DATE: JUNE 25, 2014
FROM: PFB ARCHITECTS
SUBJECT: BIDDER QUESTION RESPONSES
PROJECT: **RELOCATE JOLIET CBOC PHASE II - BID PACKAGE C**
TO: **OWNER, CONTRACTORS**

Sketch Submitted by bidder for Bidder Question #30. This is not an Architectural Drawing and is not a part of the Bid Set.

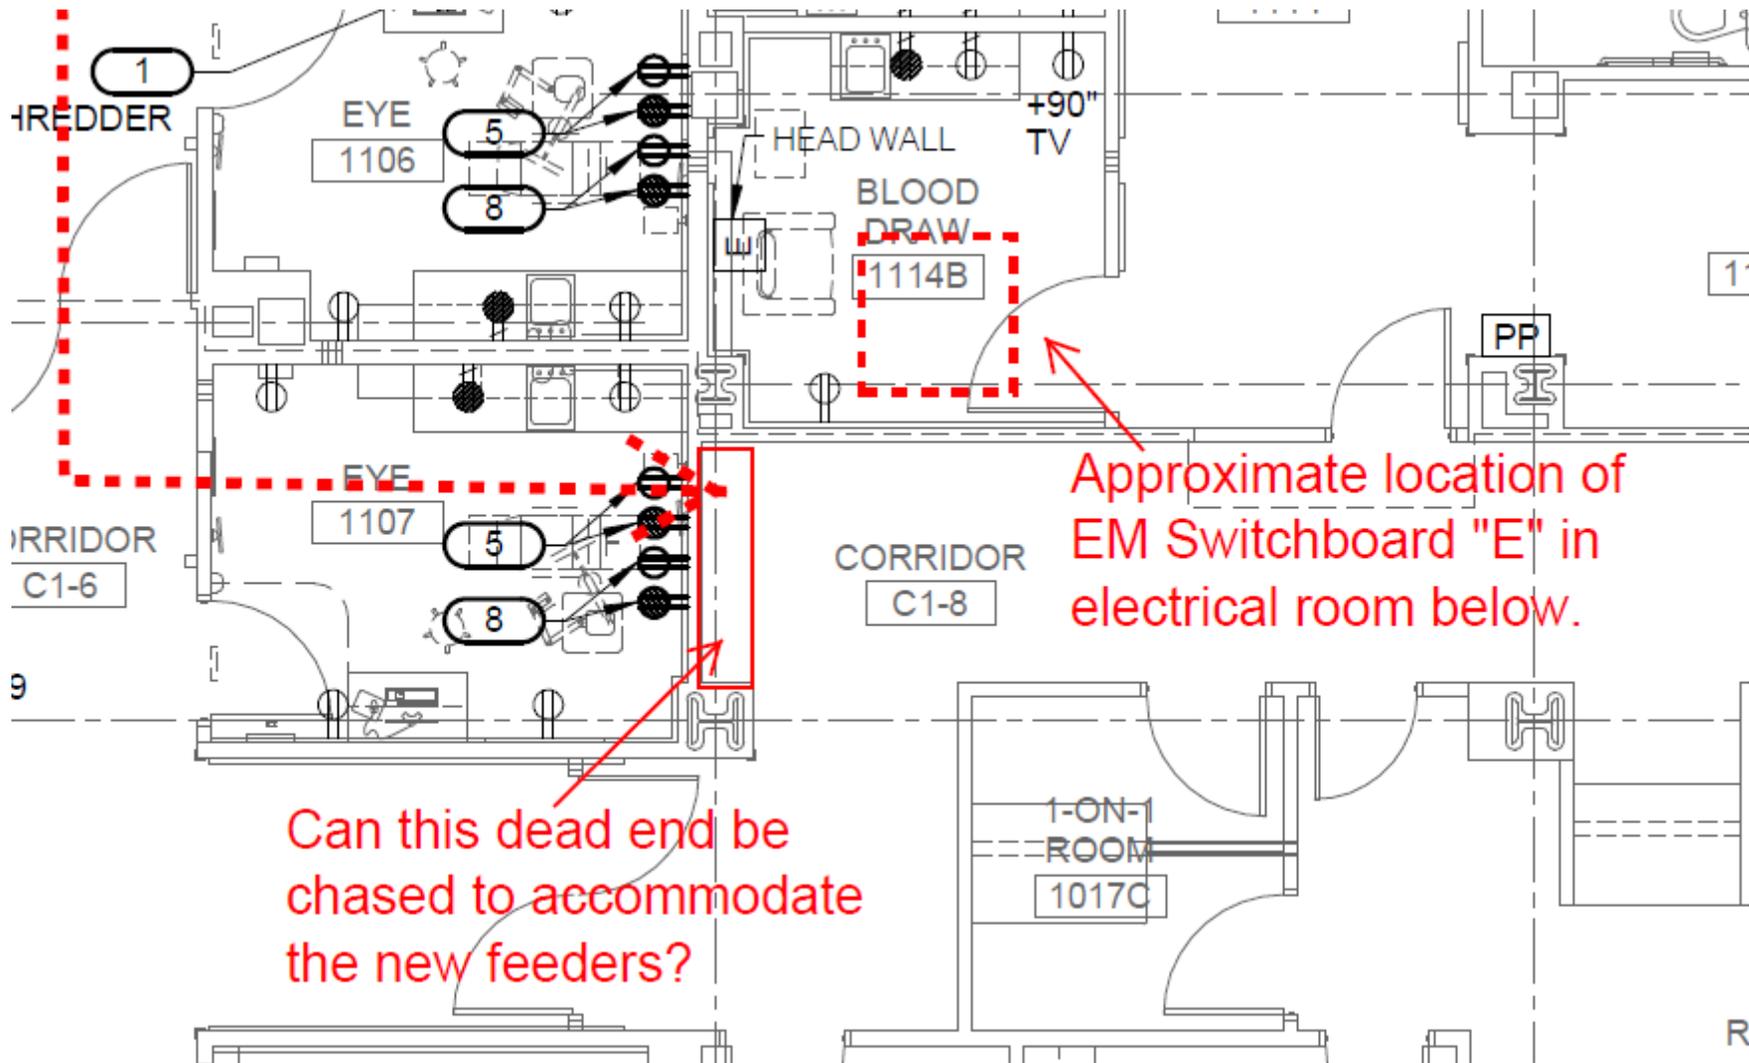
30. Re: Routing of the new Generator Feeders.
- Please review the Gen Set routing plan sketches attached and comment on whether or not a new pipe chase is feasible in the location indicated. **[A chase at the location shown is not acceptable as it is within the completed phase 1 area which will be seeing patients at the time of construction.]**

This appears to be to most convenient routing to get the New Generator Feeders down to the basement. Can this location be chased out to allow for the conduits going into the basement electrical room below?

If this location is unsuitable, can the design team recommend another suitable spot for 5-4", 3-2", 4- 1" conduits to make their way to the basement?
